PIC16C745/765 Rev. A1 Silicon/Data Sheet Errata

The PIC16C745/765 (Rev. A1) parts you have received conform functionally to the PIC16C745/765 Data Sheet (DS41124C), except for the anomalies described below.

FIGURE 1: USB TRANSCEIVER TIMING

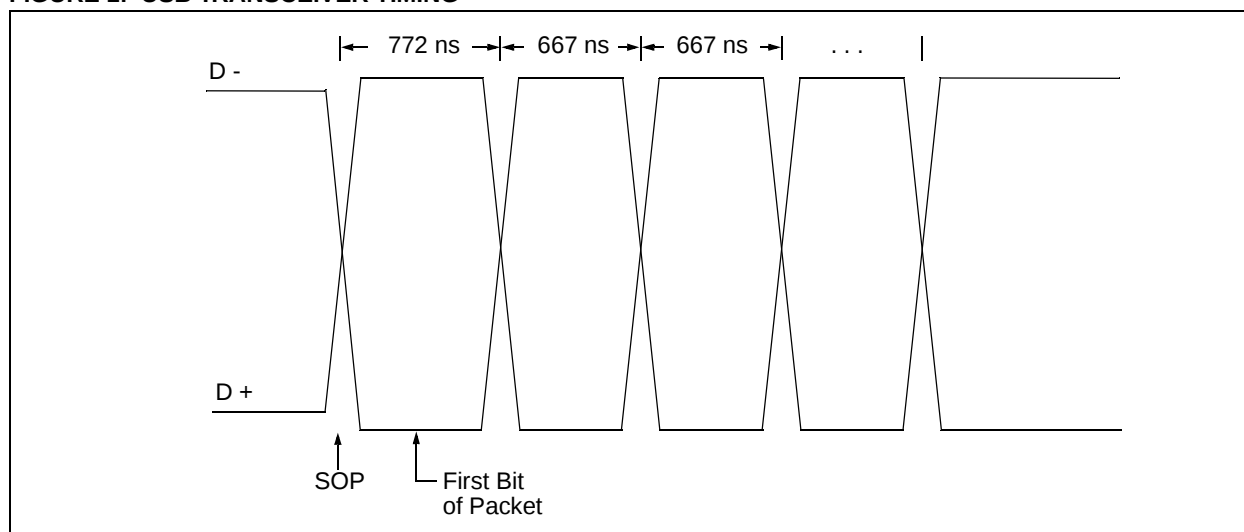
The first bit in the sync pattern during Microcontroller-to-host transactions is elongated by approximately 100 ns (see Figure 1). According to Section 7.1.11 of the USB Specification, Version 1.1, the bit period for a low speed device can vary 1.5% from 667 ns. This

means the average bit length can vary from 657 ns to 676 ns. Section 7.1.13.1 states, "For low speed transmissions, the jitter time for any consecutive differential data transitions must be within ± 25 ns and within ± 10 ns for any set of paired differential data transitions."

The initial bit from the PIC16C745/765, at approximately 772 ns in length, violates the consecutive transition jitter specification by 71 ns to 90 ns, depending on the actual data rate. It violates the paired data transition jitter specification by 82 ns to 120 ns, depending on the actual data rate. Devices based on the PIC16C745/765 are likely to fail the USB Implementer's Forum Compliance Test due to the jitter violation. However, the elongated bit does not affect the reliability of USB transactions between current USB host controllers and the PIC16C745/765. All packets are communicated successfully between microcontroller and host.

No work around available.

FIGURE 2: UIR / USTAT REGISTER

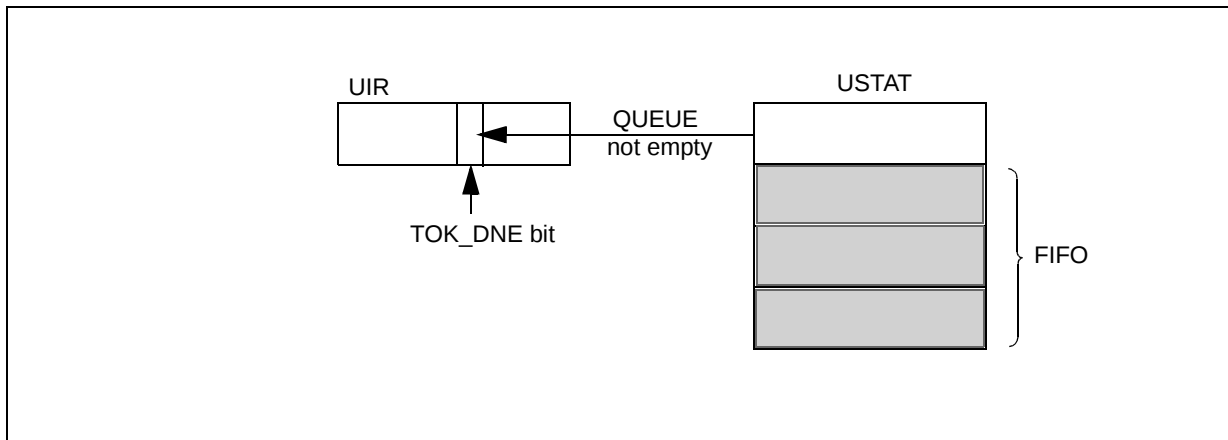
The TOK_DNE bit (UIR Bit 3) is not set correctly for pending USB transactions in the USTAT register (see Figure 2). If additional transactions arrive prior to clearing the TOK_DNE bit, they will be lost.

The interrupt driver Microchip firmware does not lose any transactions with current operating systems.

FIGURE 7-1: TIMER1 BLOCK DIAGRAM

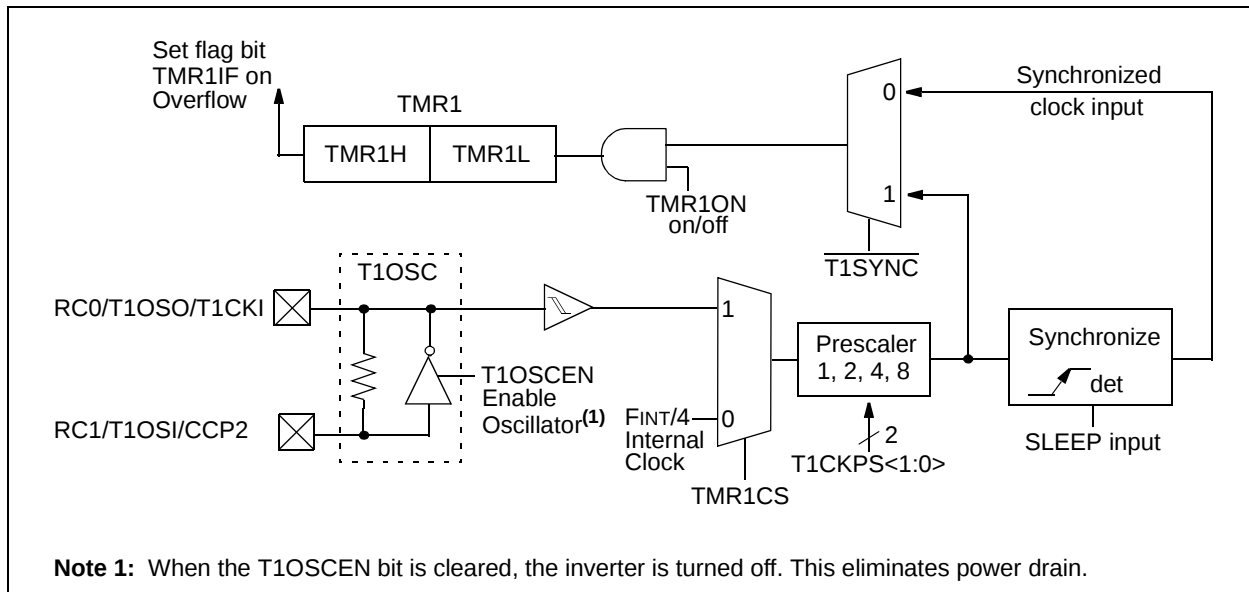
In Section 7.0, Timer1 module, there is an error in Figure 7-1. The label FINT should read FINT/4.
